U. S. ATOMIC ENERGY COMMISSION
REGION I
DIVISION OF COMPLIANCE

Report of Inspection

CO Report No. 289/69-1

Licensee: METROPOLITAN EDISON COMPANY
(Three Mile Island Nuclear
Station No. 1)
Provisional Construction Permit
No. CPPR-40

REACTOR BUILDING
 MAT POUR
 THREE MILE ISLAND NUCLEAR STATION
 UNIT NO. 1
 METROPOLITAN EDISON COMPANY
 UNITED ENGINEERS & CONSTRUCTORS INC.

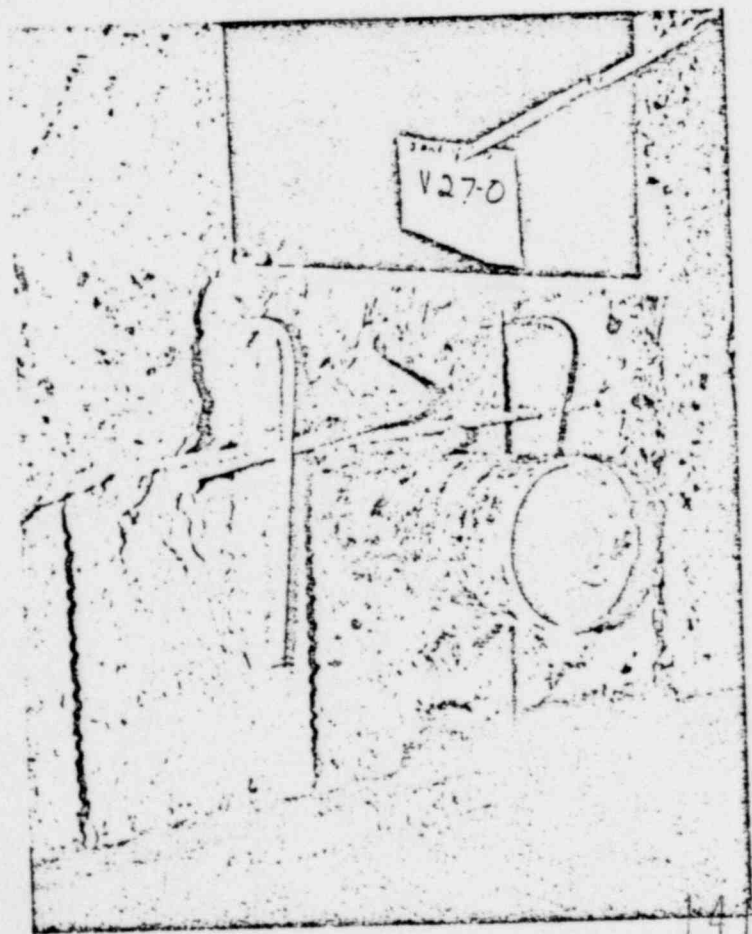
An inspection of the tendon galley after the void areas had been chipped back to solid concrete, showed that in three areas the void extended up into the concrete more than one inch. These three areas penetrated the concrete from twelve to sixteen inches (Attachment No. 1 and 2). The affected areas were between the tendon bearing plates, and in only one area was the concrete chipped out from behind the bearing plate. The space behind the bearing plate was approximately 1" wide, 3" deep, and 12-15" long. The total void volume, including the chipping, is estimated to be 4-5 cubic feet. The cause of the voids was wood and mud left in the form prior to pouring concrete.

3. The three remaining areas had been created by pieces of wood and penetrated into the concrete for depths of twelve to sixteen inches (12"-16") and would require repairs. All areas affected were between the tendon bearing plates and at only one place was the concrete chipped out from under the bearing plate and this constituted an area of approximately 1" wide by 3" deep and 12" to 15" long. (Location shown in Attachment No. 1, photographs of void areas in Attachment No. 2.)

Sections Involved: 3, 4, 5 and 6 (Attachment No. 1)
